## Product Change Notification / CENO-13WQJN777

CCB 5163 Final Notice: Qualification of MMT as an additional assembly site for selected SY100EPTxxxxx, SY100ELTxxxxx, SY100EL3xxxx and SY100EL1xxxx device families available in 8L SOIC (3.90mm) package.

**CCB 5163**  
**Pre and Post Change Summary**  
**PCN #: CENO-13WQJN777**

# LEAD FRAME COMPARISON

## MMT

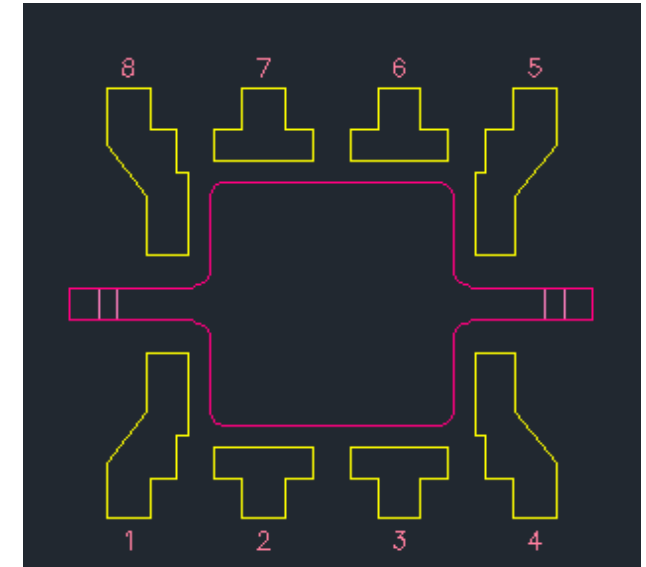
Lead frame DAP surface prep	Ag Spot
Lead Plating	Matte Tin
Lead-Frame Paddle Size	90x90 mils
